Access Compliance Report

Public Rights-of-Way

Intersection ID: 13740	Main Street: CENTRAL_AV	Cross Street: LONGFELLOW_ST	Location: NW
ADA ID: 7197A70442C1	Ramp Type: Perp	Initial Pass/Fail: Fail	Overall Compliance: No
		Severity Score: 10

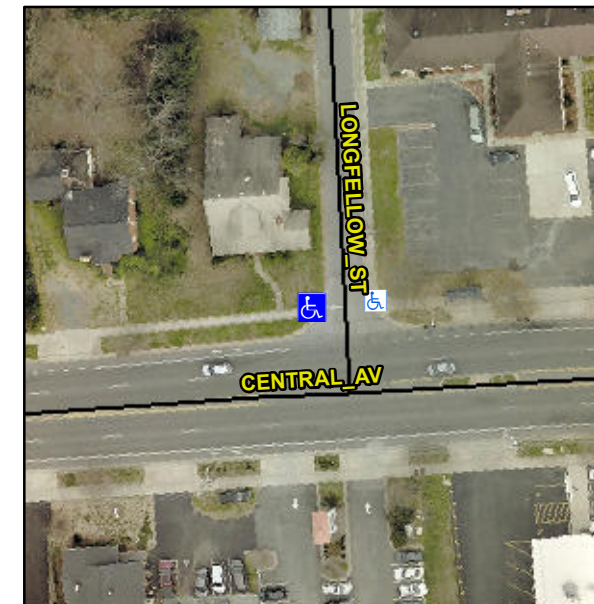
Not Found, R304.5.1, R304.5.3

Compliance	Description	Data	Compliance	Description	Data
N/A	Ramp Length (in)	86.0	Yes	Ramp Slope (%)	5.4
No	Ramp Width (in)	38.0	No	Ramp XSlope (%)	2.2
N/A	Flare Type LT	N/A	N/A	Flare Type RT	N/A
N/A	Flare Slope LT (%)	N/A	N/A	Flare Slope RT (%)	N/A
N/A	Flare Traversable LT?	N/A	N/A	Flare Traversable RT?	N/A
N/A	Landing Length (in)	N/A	N/A	DWS Provided?	N/A
N/A	Landing Width (in)	N/A	N/A	DWS Contrast?	N/A
N/A	Landing Slope (%)	N/A	N/A	DWS Length (in)	N/A
N/A	Landing X Slope (%)	N/A	N/A	DWS Full Width?	N/A
N/A	Landing Curb? (Y/N)	N/A	N/A	DWS Offset (in)	N/A
N/A	Shared Landing?	N/A			
N/A	Gutter Ponding?	N/A	N/A	Gutter Slope (%)	N/A
N/A	Gutter Lip Ht (in)	N/A	N/A	Gutter X Slope (%)	N/A
N/A	Painted X Walk1?	No	N/A	Painted X Walk2?	N/A
	X Walk 1 Direction	To E		X Walk 2 Direction	N/A
N/A	X Walk 1 Width (in)	N/A	N/A	X Walk 2 Width (in)	N/A
	X Walk 1 Slope (%)	2.1		X Walk 2 Slope (%)	N/A
	X Walk 1 X Slope (%)	0.2		X Walk 2 X Slope (%)	N/A

Remove & Replace Entire Ramp.
